ENGINE - MAIN GEARBOX ASSEMBLY - PROVIDE A NEW HYDRAULIC PUMP SHROUD - CATEGORY CODE 6
- MOD.ENG-72-0264

V2500-ENG-72-0264

SERVICE BULLETIN

Shrouds installation
Fig.1

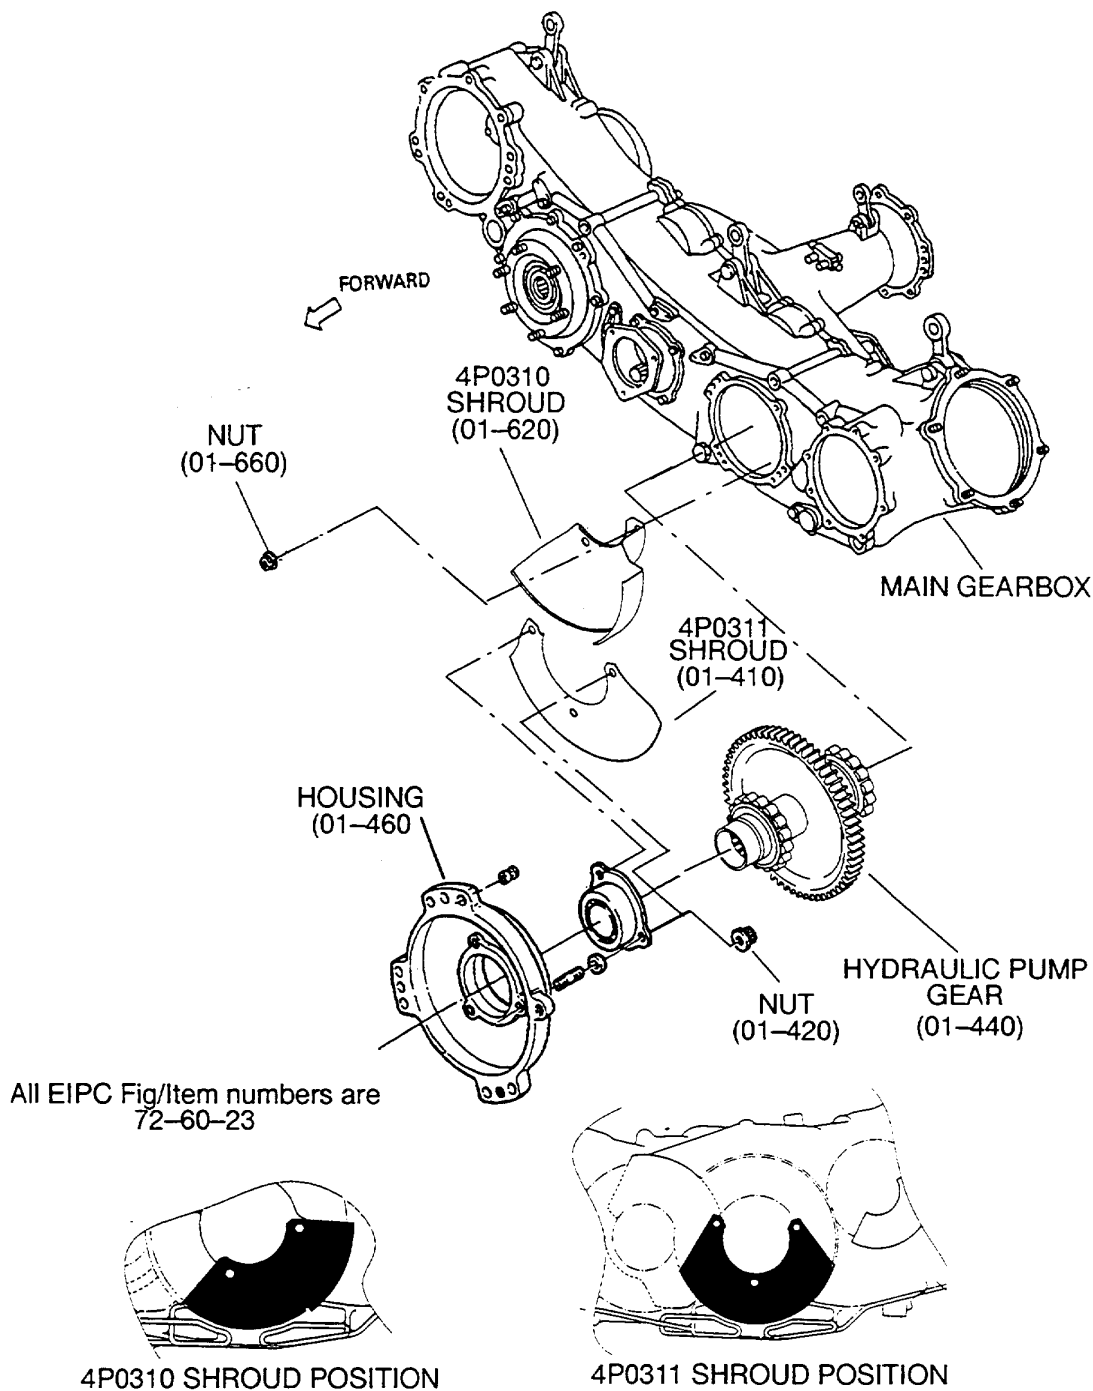
This Service Bulletin introduces a revised Hydraulic Pump Gearshaft shroud similar to the existing item except for:

- (a) The new shroud is made in two pieces
- (b) Each piece has a flange for attachment

- (1) Align the holes on the new 4P0310 shroud with the studs on the gearbox casing.
- (2) Install the new 4P0310 shroud and the three nuts which attach the outer race to the gearbox casing Torque the nuts to 85 to 95 lbfin (9,604 Nm to 10,734 Nm.).
- (3) Put the hydraulic pump drive gear in the gearbox casing. Make sure the ID splined end points to the front of the gearbox.
- (4) Install the rear roller bearing and the hydraulic gearshaft in to the outer race installed in the gearbox casing
- (5) Remove the three nuts that secure the outer race to the hydraulic pump housing
- (6) Align and install the new 4P0311 shroud on to the outer race. Install the nuts and torque to 85 to 95 lbfin (9,604 Nm to 10,734 Nm.)
- (7) Complete the installation, refer V2500 Engine Manual, Chapter/ Section 72-60-10, Disassembly/Assembly
